The Foxboro Company

14 December 1990

Reference: Foxboro Model No. N-E13DM-IHM2
or Spare Part No. N0141FN

Figure No. 1

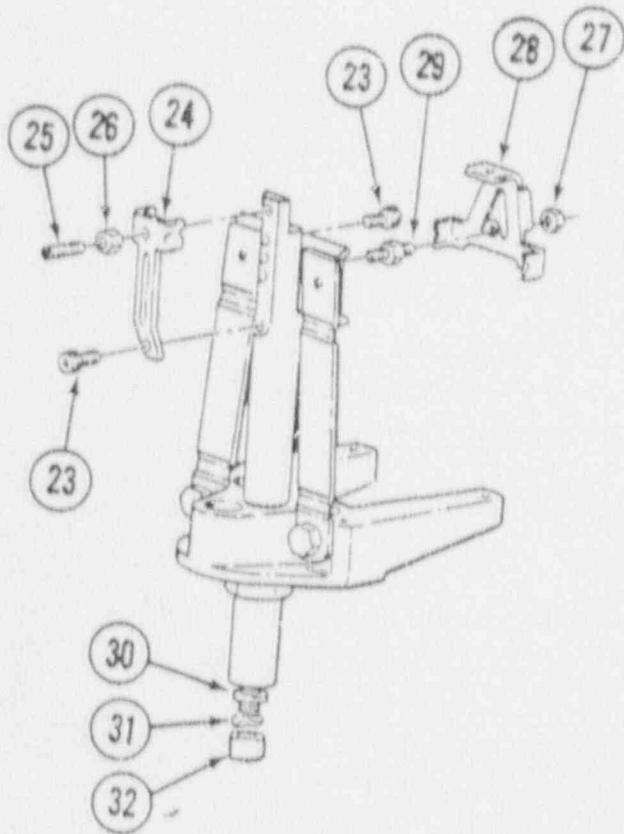
In compliance with 10CFR Part 21.21(a)(1) (ii), this letter is to notify you that we may have shipped you either a transmitter with an improperly processed part and/or the part itself. The subject part is Part No. N0141FN, a bracket, and is identified as number 24 in the attached Figure No. 1. The bracket is located in the transmitter topworks at the top of the force bar assembly and provides topworks static alignment and overrange protection. In August of 1989 the bracket material was changed to a 410SS, which requires a two step heat treating process, instead of a single step process, for proper material characteristics. The correct process change was not implemented until Jan.-Feb. 1990. Single step heat treatment of 410SS allows cracks to form near the bracket mounting hole and from which the cracks will continue to propagate, thus weakening the bracket. This discrepancy was discovered only very recently. Weakening brackets may cause one of the following to occur:

Visual inspection will not reveal the existence of cracks because of bracket painting but different bracket finishes do identify suspected or faulty processed brackets. Unfinished/unpainted brackets and brackets with a "Gray" painted finish must be replaced. Brackets with a "Silvery" finish similar to the finish on the "Forcemotor" are correctly processed and replacement is not necessary.

Use of applicable Foxboro Master Instructions (MI's) will be required to properly align the specific transmitter after bracket installation. It is recommended that only personnel trained in Foxboro Transmitter servicing should perform bracket replacement and transmitter re-alignment. Replacement brackets 24 include screw 25 and locking nut 26 as in Figure No. 1, attached. The mounting screw 23 can be re-used for bracket replacement.
